SUBJECT: ISSUANCE OF AMENDMENT NO. 54 TO FACILITY OPERATING LICENSE
NO. NPF-21 - WPPSS NUCLEAR PROJECT NO. 2 (TAC NO. 66808)

This amendment revises snubber functional testing sampling plans as detailed in Technical Specification 4.7.4.e.

SAFETY EVALUATION BY THE OFFICE OF NUCLEAR REACTOR REGULATION
SUPPORTING AMENDMENT NO. 54 TO FACILITY OPERATING LICENSE NO. NPF-21
WASHINGTON PUBLIC POWER SUPPLY SYSTEM
WPPSS NUCLEAR PROJECT NO.2

FIGURE 4.7-1
 SAMPLE PLAN 2) FOR SNUBBER FUNCTIONAL TEST

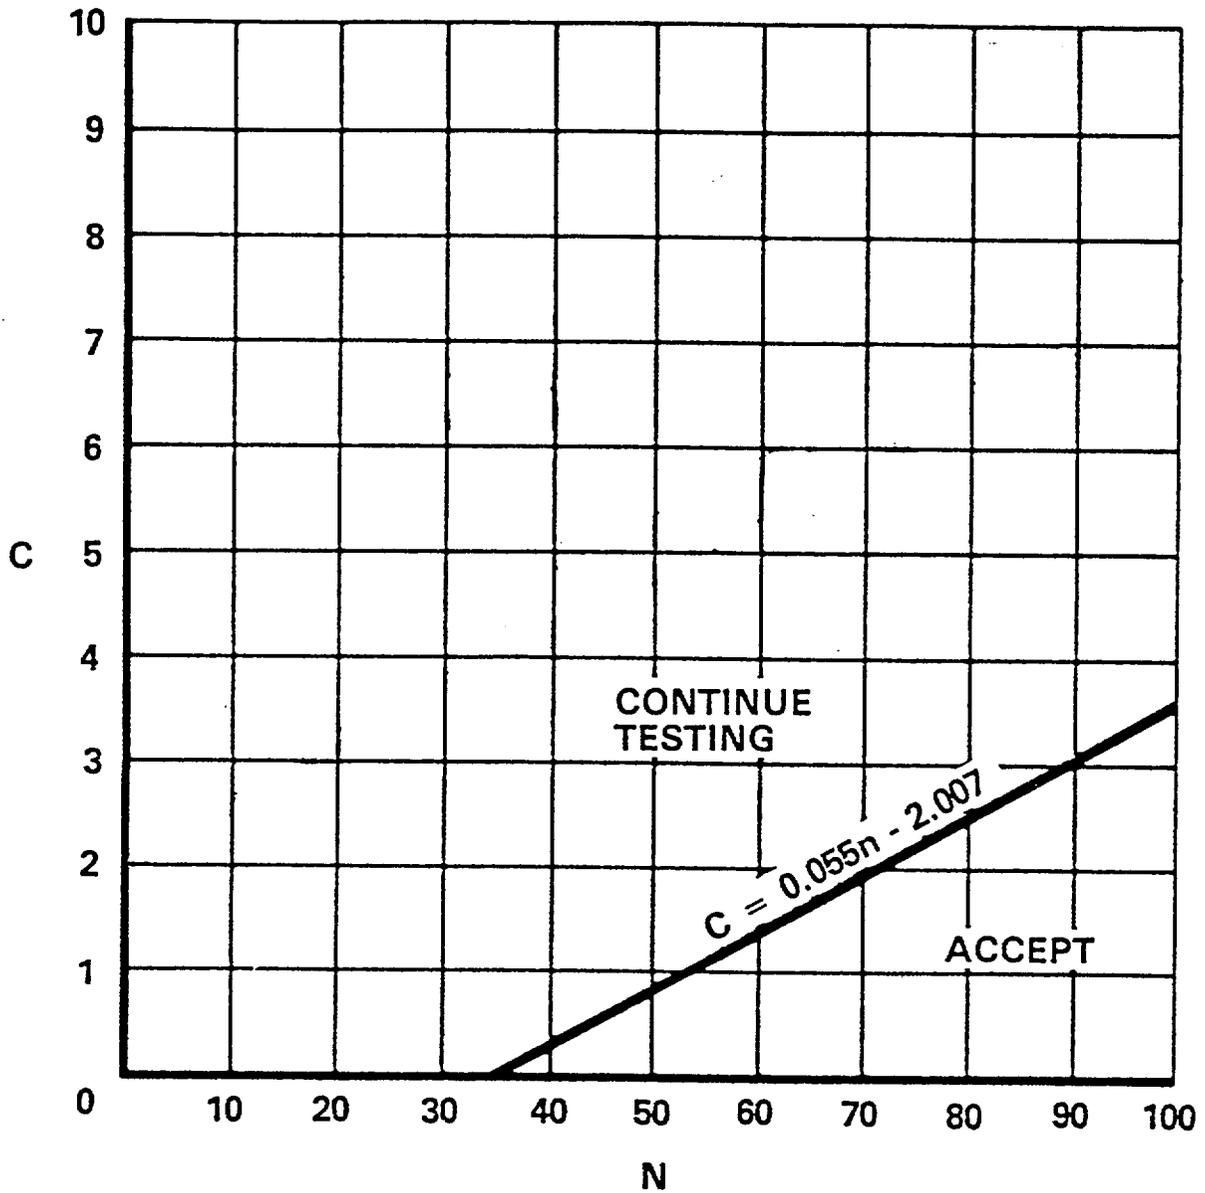
The proposed change revises surveillance requirement 4.7.4.e(2) and Figure 4.7-1 to delete the "reject" region and substitute an expanded "continue testing" region. With the deletion of the "reject" line plotting of results by lot or individual basis becomes a moot point because snubbers must continue to be tested until the point falls into the "accept" region or until all snubbers have been tested.

The proposed change also deletes references to the "reject" region in the text of Specification 4.7.4.e(2) and bases 3/4.7.4. In the December 1, 1987 submittal, the licensee proposed that bases 3/4.7.4 be supplemented by a footnote such that if testing continues to be between 100-200 snubbers and the accept region has not been attained, then the actual percent of population quality of greater than or equal to 5% failed snubbers will probably result in extended testing. The staff finds that the footnote does not add to or clarify the Technical Specification requirements. By letter dated March 18, 1988, the licensee retracted the proposal for the footnote.

- 2) A representative sample of 37 snubbers shall be functionally tested in accordance with Figure 4.7-1. "C" is the total number of snubbers found not meeting the acceptance requirements of Specification 4.7.4f. The cumulative number of snubbers of a type tested is denoted by "N". If at any time the point plotted falls in the "Accept" region, testing of snubbers may be terminated. When the point plotted lies in the "Continue Testing" region, additional snubbers shall be tested until the point falls in the "Accept" region or all the snubbers have been tested. Testing equipment failure during functional testing may invalidate that day's testing and allow that day's testing to resume anew at a later time provided all snubbers tested with the failed equipment during the day of equipment failure are retested.

Regarding the proposed changes in the second sampling plan, the acceptance criteria (represented by Figure 4.7-1 in the Technical Specifications) were developed using "Wald's Sequential Probability Ratio Plan". Statistical studies using Wald's sequential sampling plan indicate that

a major change in the reject line caused an insignificant change in the accept line or in other words acceptance is independent of rejection. These studies also demonstrate that while the probability of false acceptance of a bad snubber population under the proposed amendment still exists it is negligible. As long as the "reject" line remains in the sample plan there is some possibility of rejecting a good snubber population and consequently requiring an unnecessary 100% functional testing of snubbers with attendant ALARA and safety concerns, manpower utilization and outage extension. The proposed technical specification change will alleviate these problems and still ensure continued or additional testing if snubber quality of failed snubbers is equal to or greater than 5%.
